Product Support Bulletin 2005-004

Maintenance of Way ~ Work Equipment Bulletin

SUBJECT: Cab Threshold Filler Strip - 13108606

MACHINE MODEL(S): CX Spiking Machines with Cabs

Figure 1

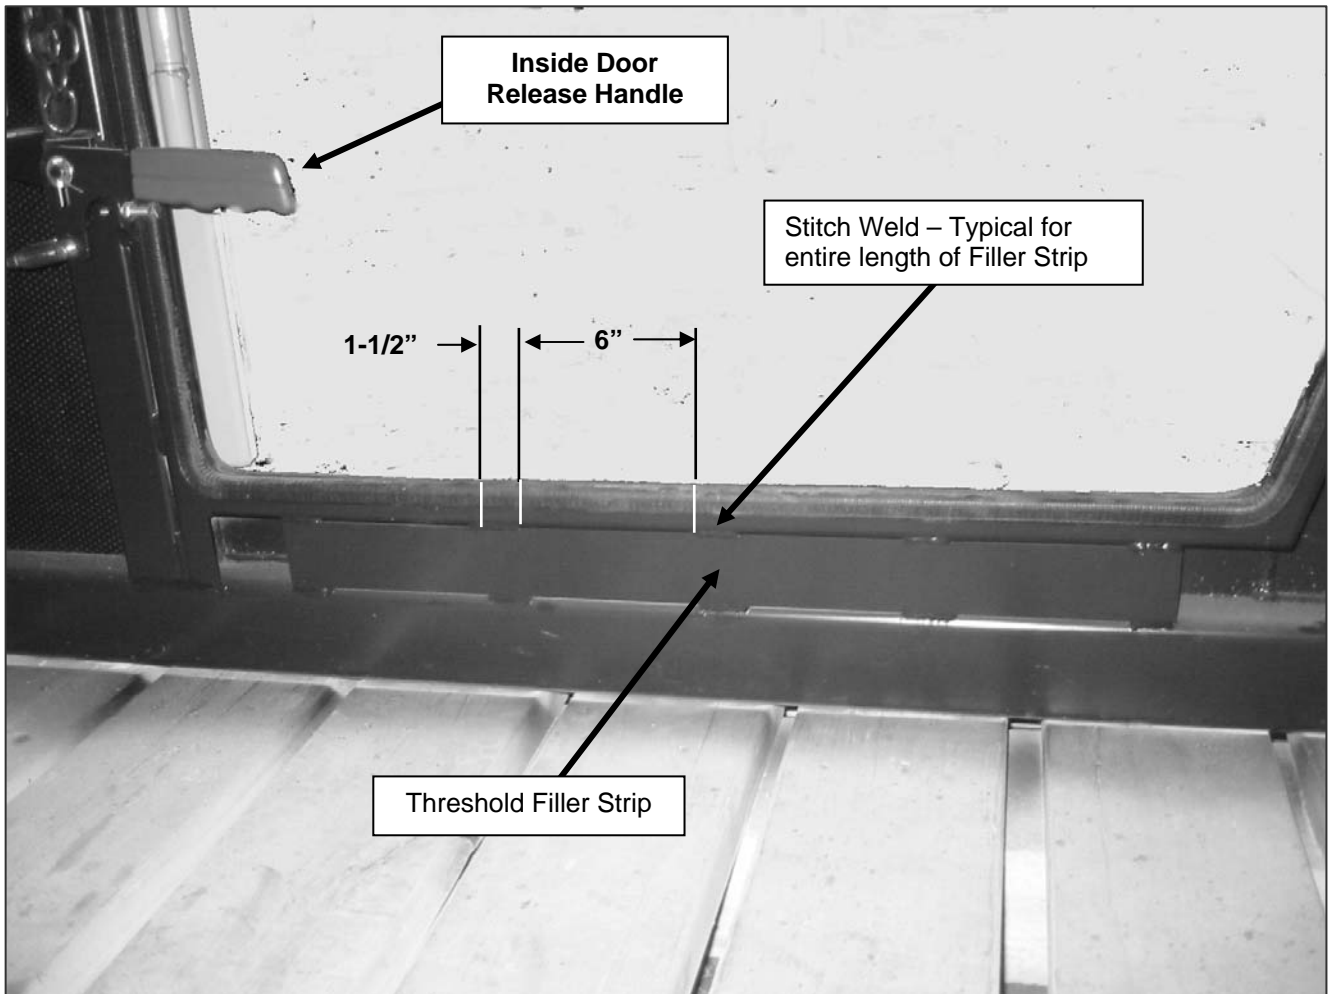
SUMMARY: Add a Filler Strip to the cab entry door threshold.

OPERATIONAL IMPACT: The entry door threshold is formed in the shape of a channel with the open side of the channel toward the inside of the cab. This opening is large enough that the toe of a work boot could fit into it while the operator is exiting the cab possibly causing the operator to lose his balance. The Filler Strip will cover the open area of the door threshold to prevent this from occurring.

ACTION: The **Filler Strip (p/n 13108606)** is welded to the open side of the threshold with 1-1/2" long stitch welds, 6" apart. See Figure 1.
